Document type: Standard Operating Procedure	FSCA Reference FSOP450-4	
<u>Urgent Field Safety Notice</u>		Revision A	Authored Date: 2020-05-26

Agility Automated ELISA System

Information on Affected Devices/Products	
1	Device Type(s)
	The Agility Analyzer is an In Vitro Diagnostic Medical Device used for automating the steps of ELISA assays.
2.	Commercial name(s)
	Agility
3.	Unique Device Identifier(s) (UDI-DI)
	5060456180058
4.	Primary clinical purpose of device(s)
	The Agility Analyzer is intended for automating ELISA assays. The user combines the Agility with an Assay changing the Agility intended use from an open system into a specific Analyzer for automating the steps for the assay.
5.	Device Model/Catalogue/part number(s)
	67000 Agility Automated ELISA System
6.	Software version
	Software for Agility (REF# 67800) version 1.4.3
7.	Affected serial or lot number range
	All Agility Analyzers that have software version 1.4.3
8.	Associated devices
	None identified

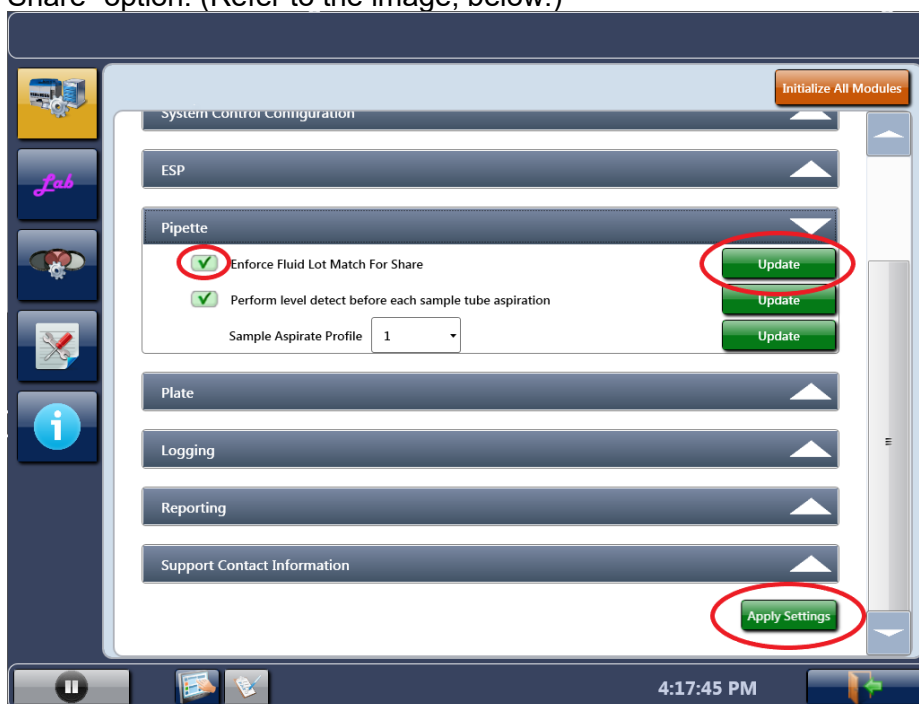
A work around has been provided to prevent the problem from occurring while the software is being improved. **Please take immediate action:**

1. From the home screen in Agility, click the icon that looks like a cog wheel or gear in front of the Agility and a computer.

2. On the next screen, which is the lab information screen, click on the same icon as before. This will open the Agility's configuration screen.
3. Make sure that the checkbox next to "Enforce Fluid Lot Match For Share" is checked.
4. Click on the "Update" button alongside the "Enforce Fluid Lot Match For Share" option. (Refer to the image, below.)

5. Scroll down to the bottom of the configuration screen to click on the "Apply Settings" button.
6. Select the "Dashboard" icon on the bottom of the screen to return to the "Home" screen

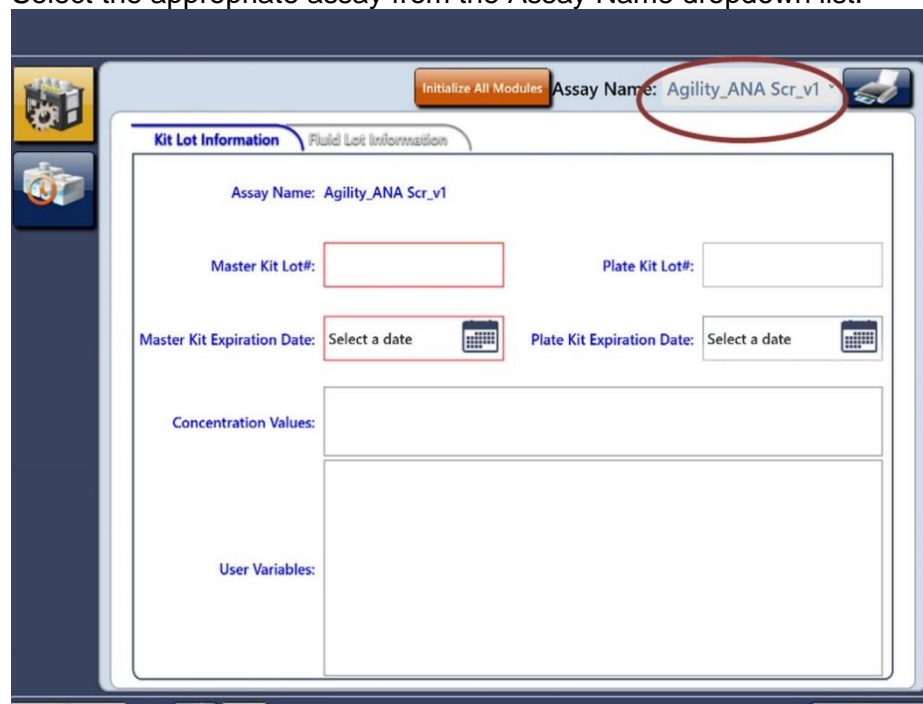
7. SmartKit barcodes can be printed by going to the “Home” icon, ,

then the Tools button by selecting

8. Select the appropriate assay from the Assay Name dropdown list.

9. Input SmartKit information for the barcode label to be printed.

**Enter the Master kit lot, Plate Kit Lot,
as well as expiry dates for both.**
